From: Schultz, Josie M - DNR
Sent: Thursday, April 22, 2021 10:07 AM
To: Beth Erdman
Cc: Mitch Hubert; pamela.havelka-rivard@perimeter-solutions.com; Brian Youngwirth; McKnight, Kevin - DNR
Subject: RE: The Solberg Co 03-05-584180: Proposed Scope and Petroleum/PFAS Groundwater Results

DNR has reviewed the workplan for continued investigation of PFAS compounds submitted for The Solberg Co, BRRTS # 03-05-584180, and concurs with monitoring well placement and sampling of the upper 4 feet of soil with the following recommendations as well:

PROPOSED SOIL BORING / MONITORING WELL LOCATION MAP
THE SOLBERG COMPANY
1520 BROOKFIELD AVE.
VILLAGE OF HOWARD
BROWN COUNTY, WI

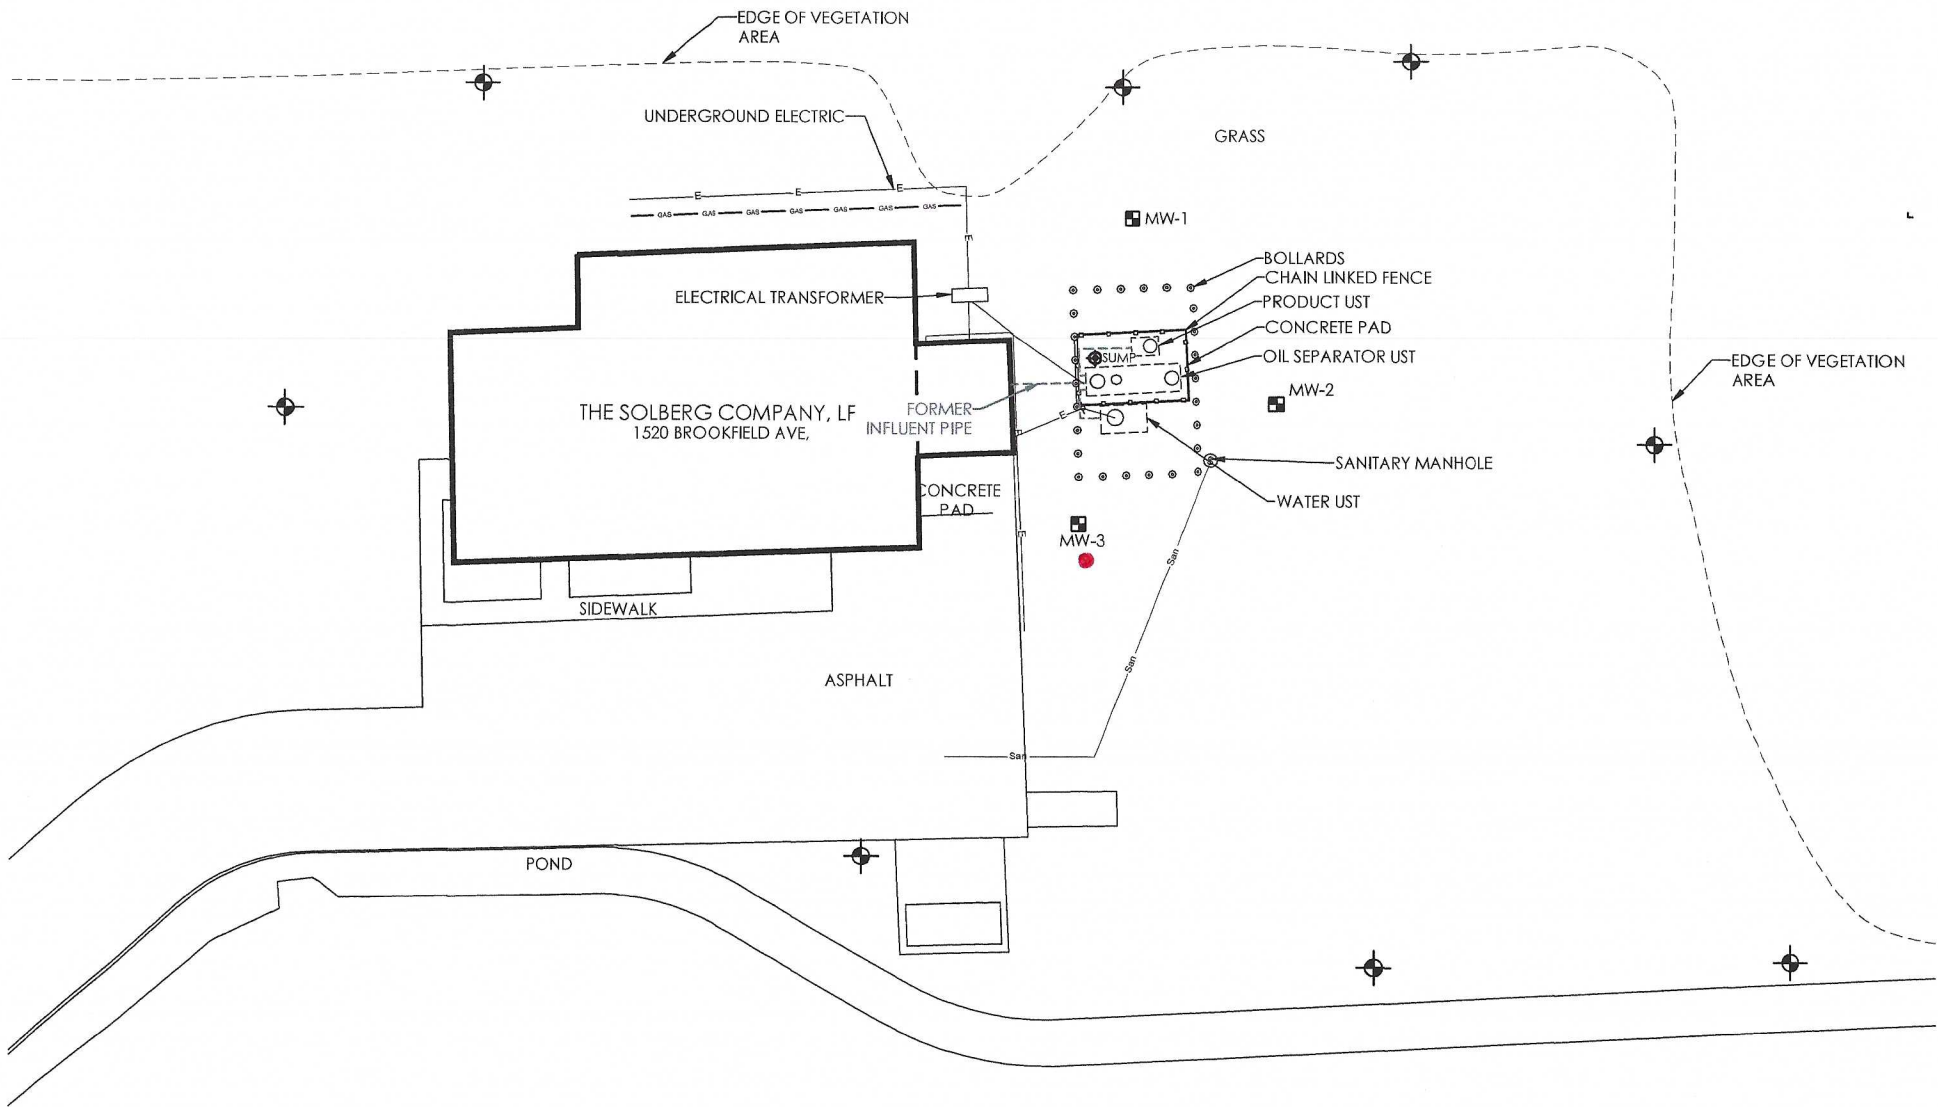
1. Recommend a nested well be installed directly downgradient or in the vicinity of MW-3 to sample deeper groundwater as well;
2. Recommend also grabbing a surface water sample (i.e. directly at the air/water interface) from the on-site pond; and

Based on the above, please also review the PFAS table and attached proposed well location map and let us know if you have any questions or concerns, specifically to the proposed locations. GEC would propose to move forward with the advancement of the of soil borings (1 soil sample from the upper 4 feet of each boring) at these locations followed by installation of shallow monitoring wells with samples collected from each of the wells and submitted to two to three labs per well location. Results will be submitted upon receipt from the labs (which is taking up to 3 months at this time and is the reason for the delay in this submittal).

DNR has reviewed the site investigation workplan for additional monitoring well installation, piezometer installation, and soil and groundwater sampling. Please accept this email as DNR's notice to proceed with the work that was outlined.

I have attached the map identifying the proposed locations of the monitoring wells and the piezometer (red dot) adjacent to MW-3. As you and I discussed this piezometer will be screened from 23-28 ft. below ground surface. GEC will also add the surface water sample from the stormwater retention pond to the scope of work. Soil and groundwater samples will be analyzed for the WDNR 33 PFAS compounds. Soil and groundwater samples will be analyzed by the WI State Lab of Hygiene. In addition, groundwater samples will also be analyzed by Pace Analytical Services and SGS AXYS Analytical Services. As part of the investigation, GEC will conduct an assessment of potable/municipal wells in the area. If this is agreeable, I will proceed with working to get this on the schedule (note that drilling companies are out 6-8 weeks minimum at this time). Upon installation, sampling will follow.
